Co3197 – Colchester HES NH 5600(14) C/2 Re-Ad

ADDENDUM #3

Changes have been made to the documents located on the Bid Opportunity website as noted below:

PROJECT NAME: COLCHESTER
PROJECT NUMBER: HES NH 5600(14) C/2 (Re-Ad)
FILE NAME: swm_det03.dgn
PROJECT LEADER: M. LACROIX
DESIGNED BY: B. TIETZE
DRY POND PLAN SHEET 2
PLOT DATE: 4/2/2025
DRAWN BY: HSD
CHECKED BY: HSD
SHEET 188 OF 405

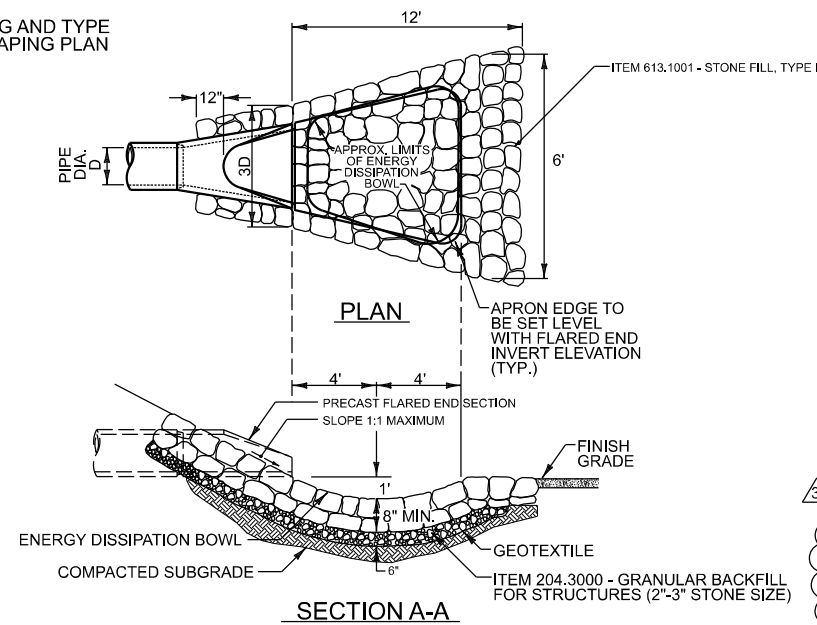
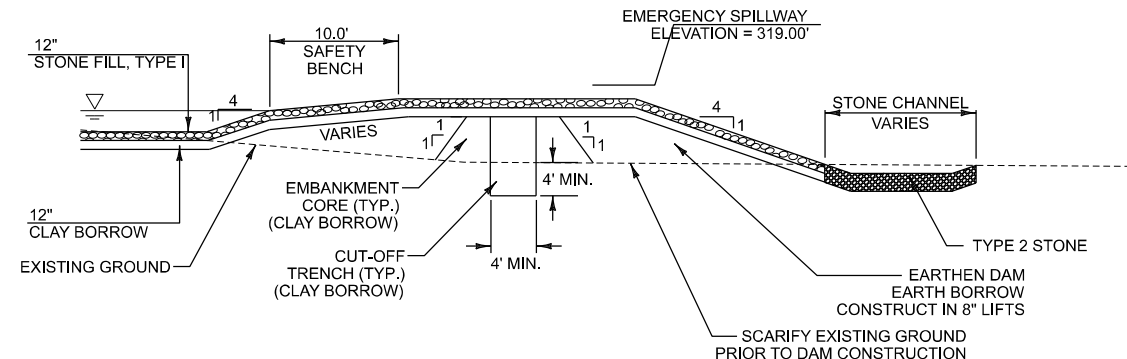
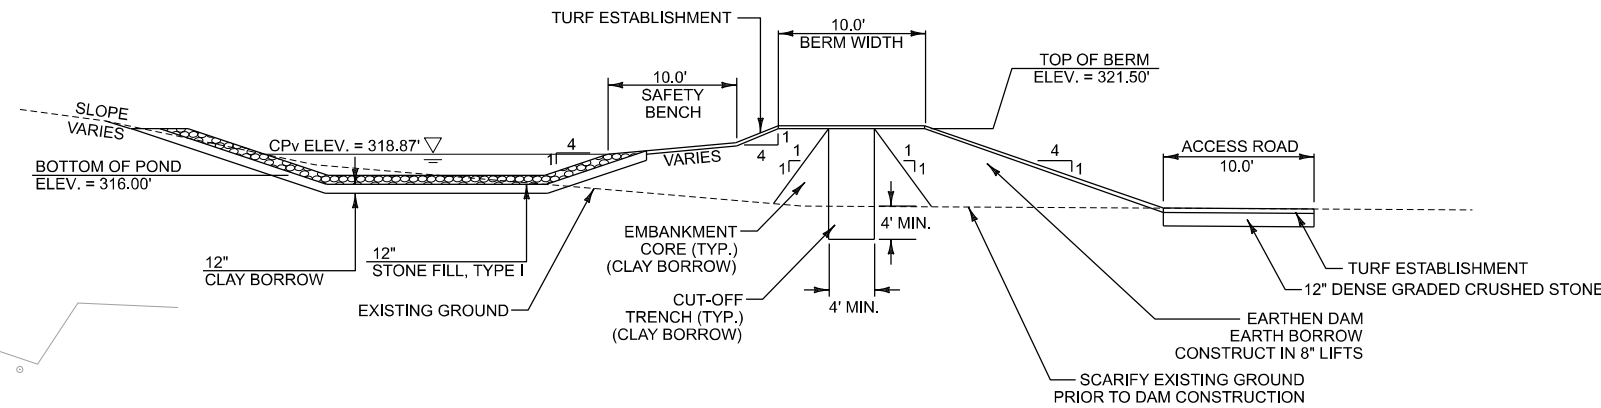
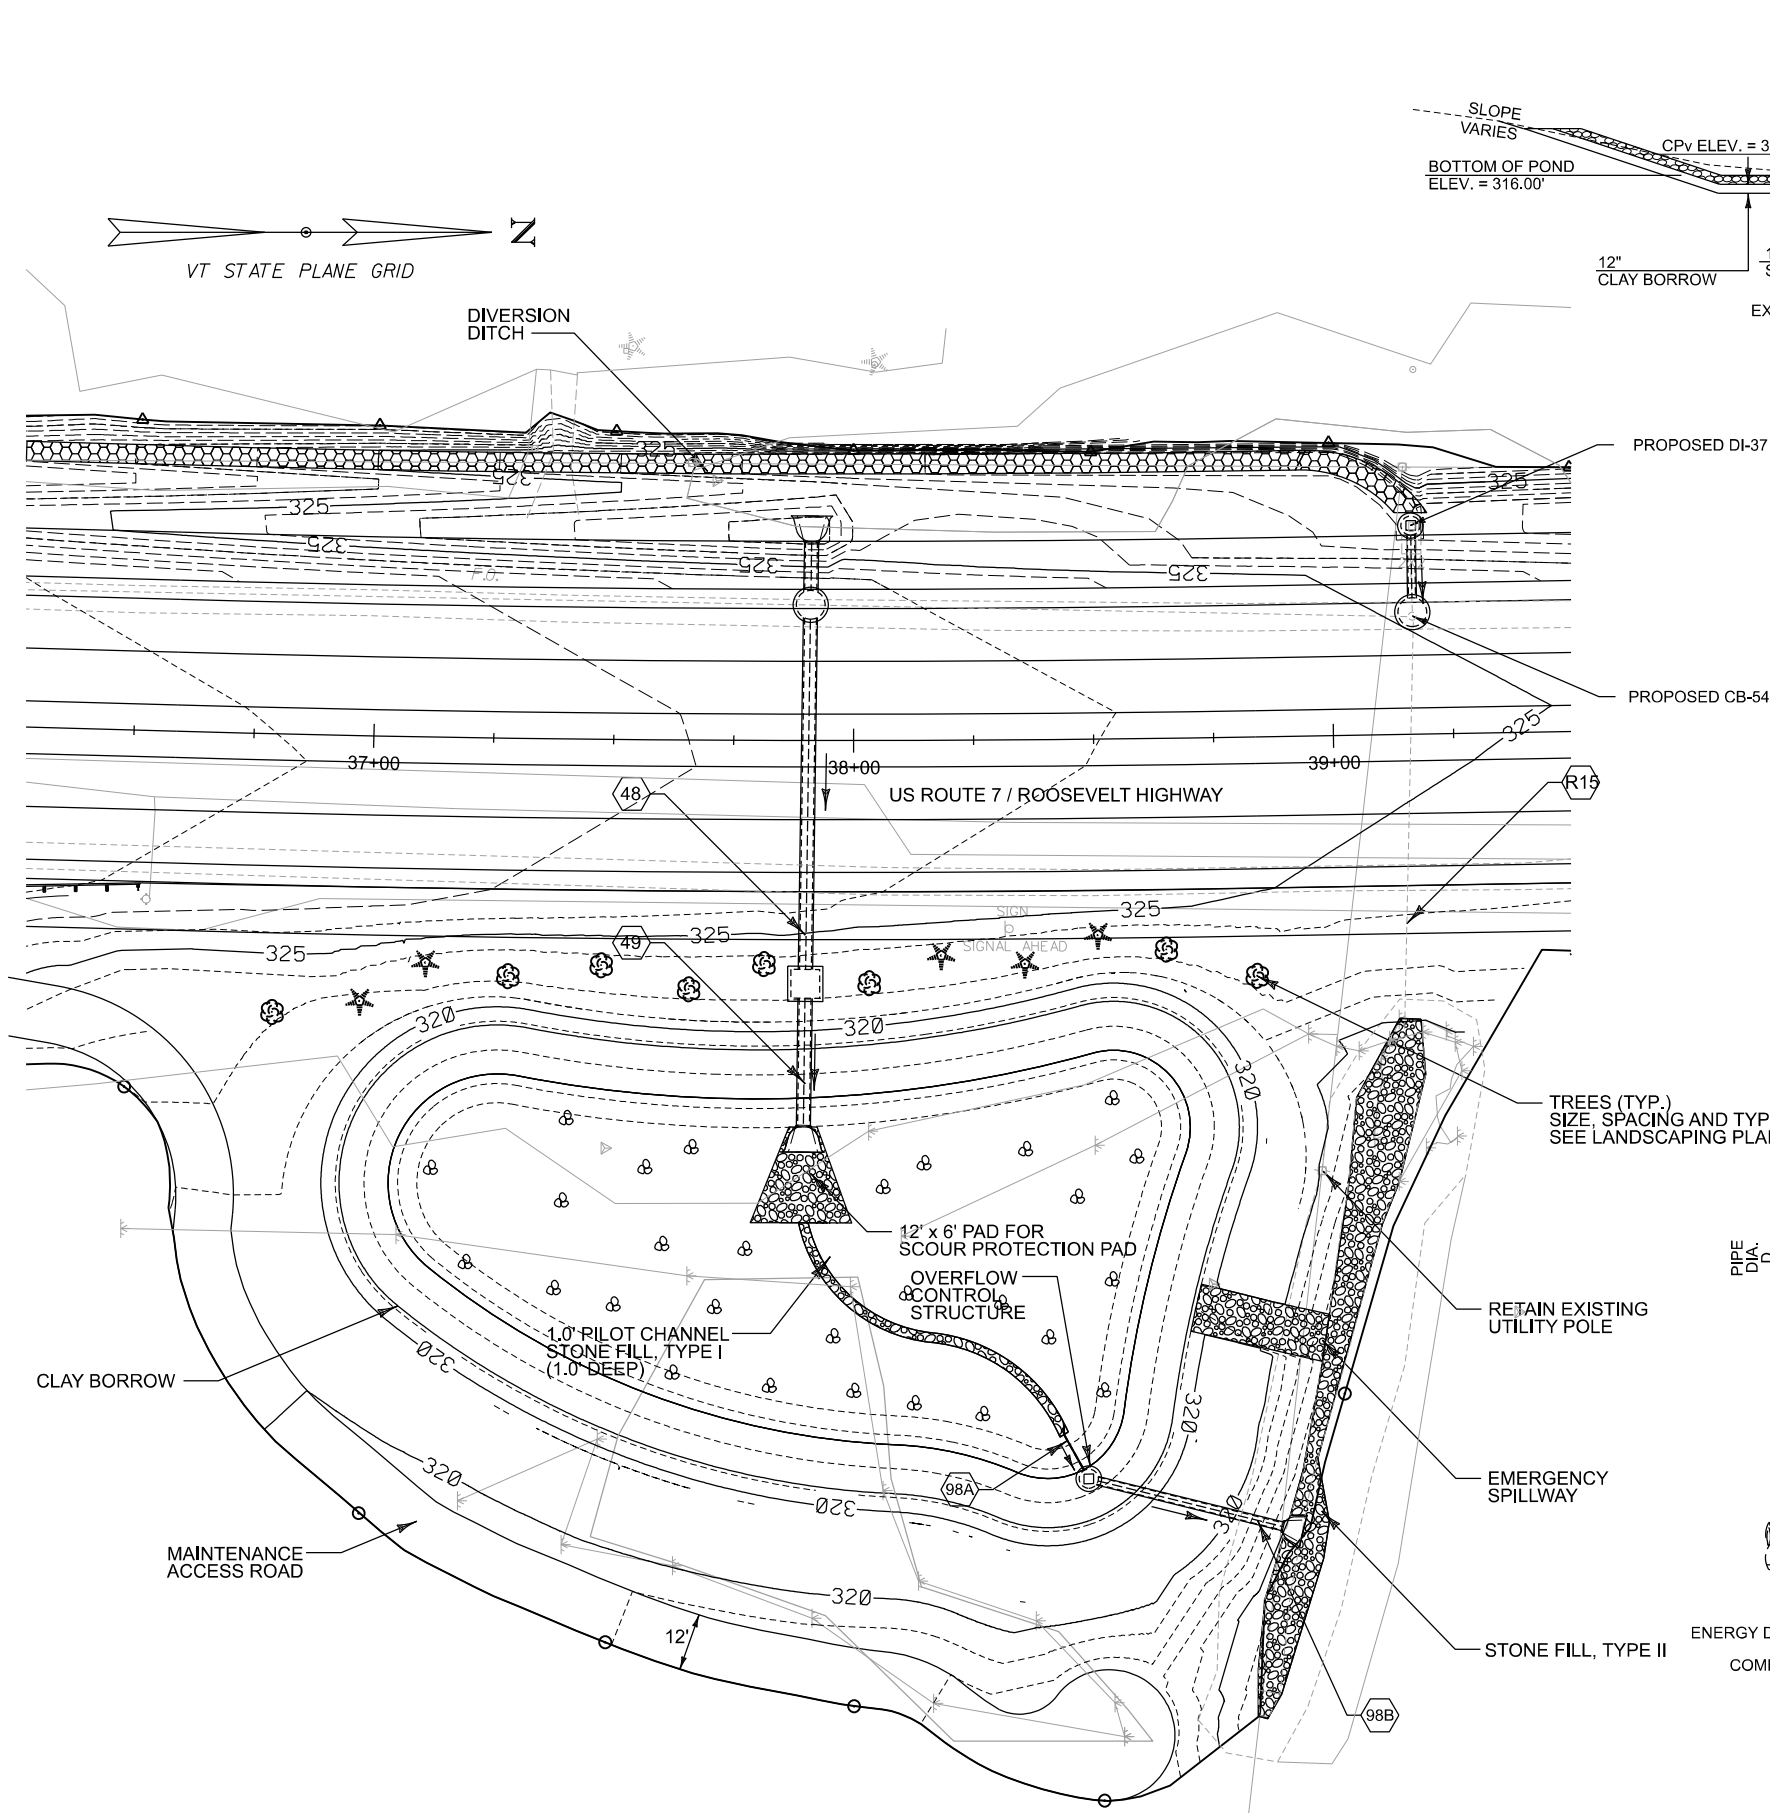
ADDENDUM	REVISION	PLOT DATE	DESCRIPTION	BY
3	1	31 MAR 2025	ADJUSTED THRUST BLOCKS TO MATCH DETAIL	BJT

PROJECT NAME: COLCHESTER		PLOT DATE: 4/2/2025	
PROJECT NUMBER: HES NH 5600(14) C/2 (Re-Ad)		DRAWN BY: HSD	
FILE NAME: swm_det04.dgn		CHECKED BY: HSD	
PROJECT LEADER: M. LACROIX		SHEET 189 OF 405	
DESIGNED BY: B. TIETZE			
DRY POND PLAN SHEET 3

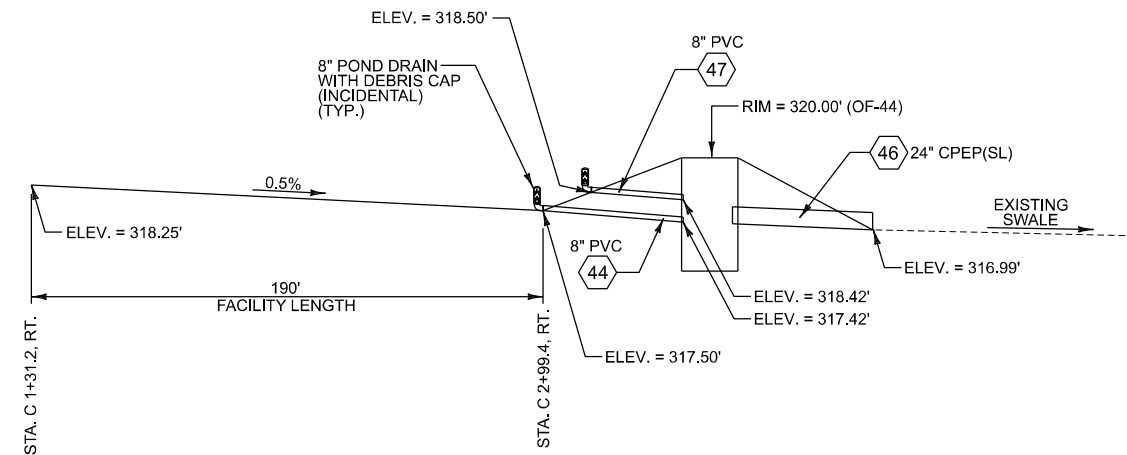
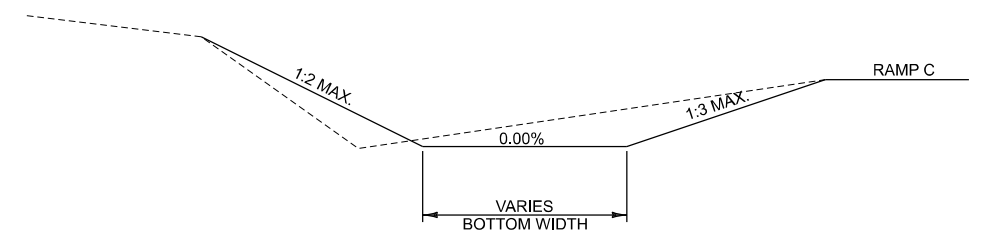
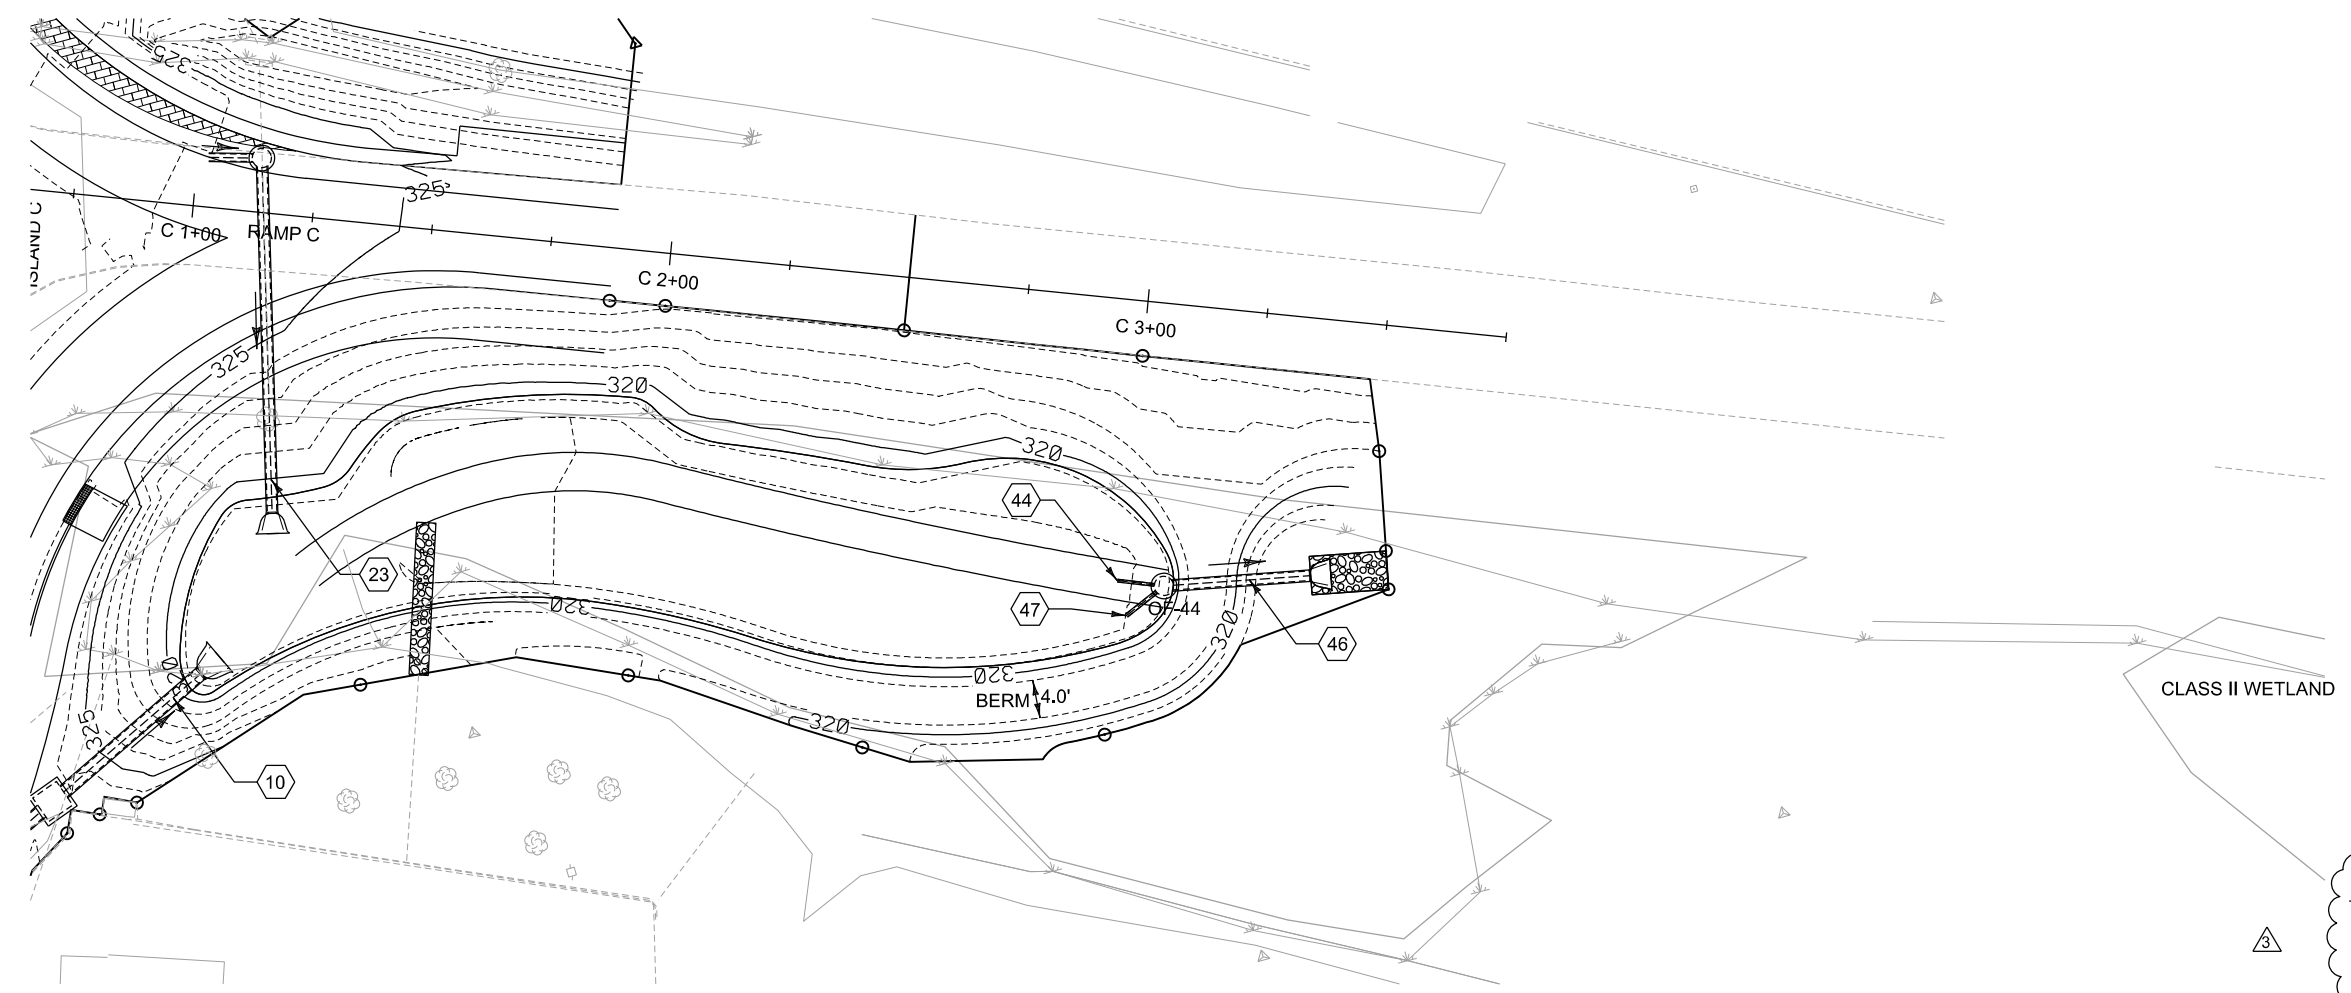
ADDENDUM	REVISION	PLOT DATE	DESCRIPTION	BY
3	1	31 MAR 2025	ADJUSTED THRUST BLOCKS TO MATCH DETAIL	BJT

PROJECT NAME: COLCHESTER	
PROJECT NUMBER: HES NH 5600(I4) C/2 (Re-Ad)	
FILE NAME: Ind_det05.dgn	PLOT DATE: 4/2/2025
PROJECT LEADER: M. LACROIX	DRAWN BY: A. ELHAJJ
DESIGNED BY: J. BROWN	CHECKED BY: T. SISSON
LANDSCAPING DETAILS SHEET I	
SHEET 248 OF 405

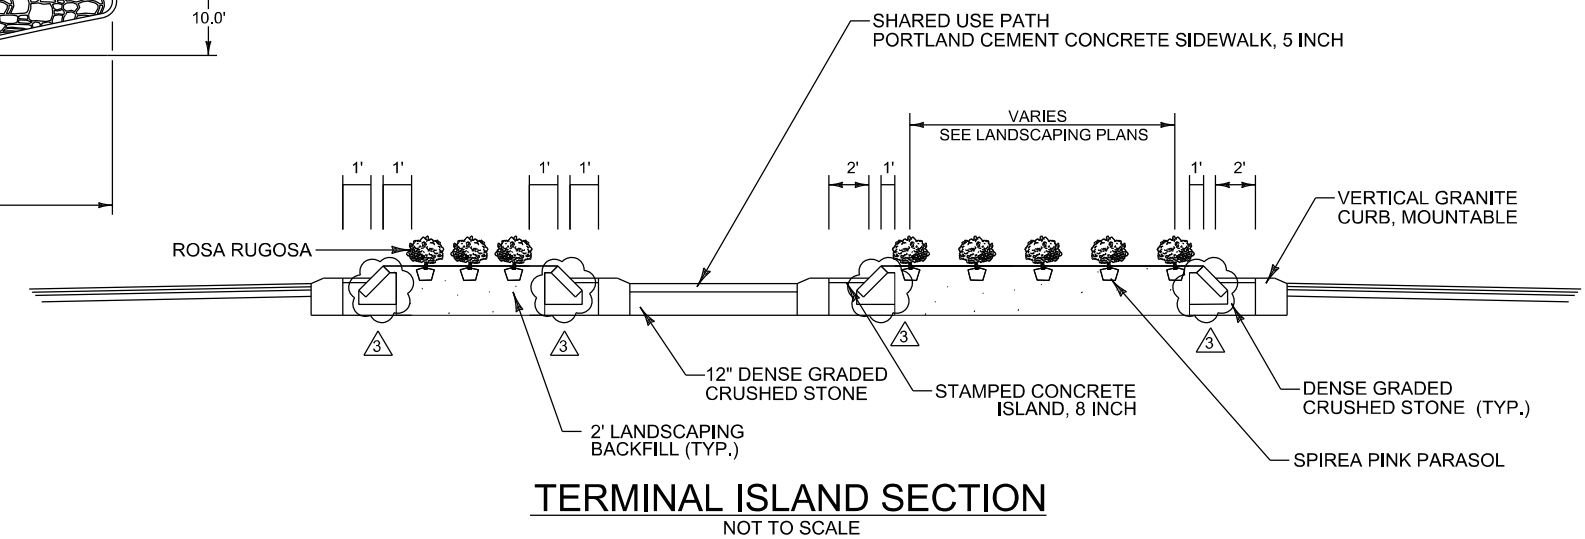
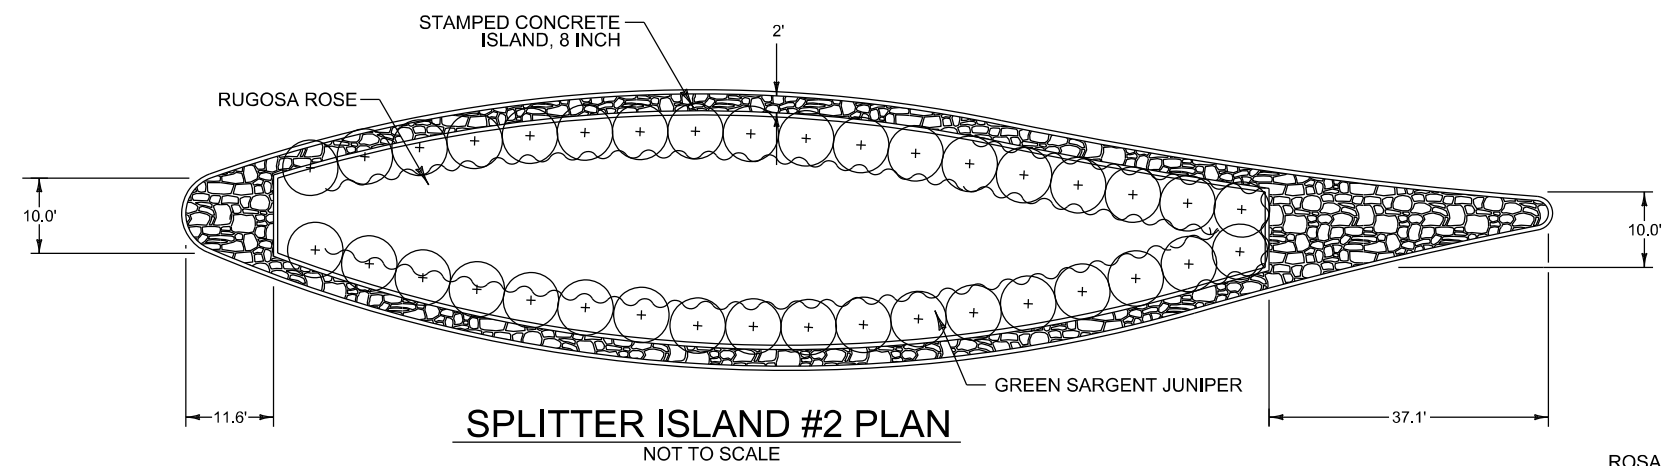
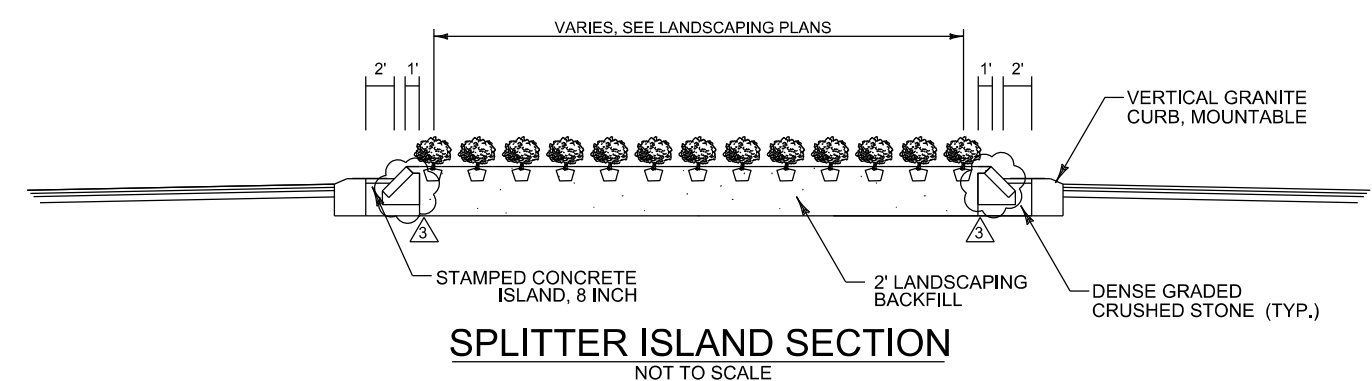
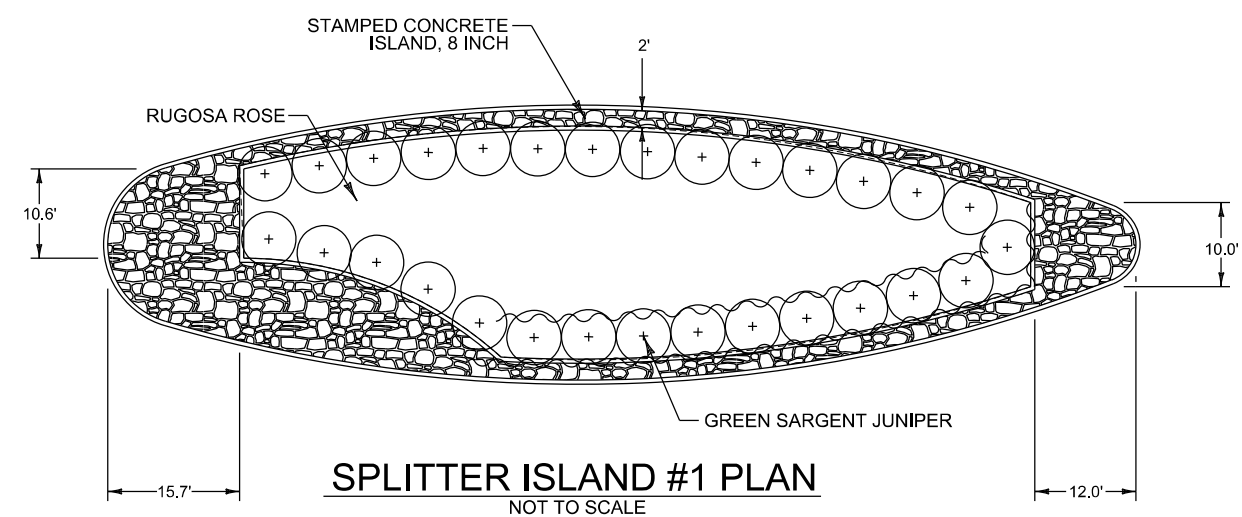
ADDENDUM	REVISION	PLOT DATE	DESCRIPTION	BY
3	1	31 MAR 2025	ADJUSTED THRUST BLOCKS TO MATCH DETAIL	BJT
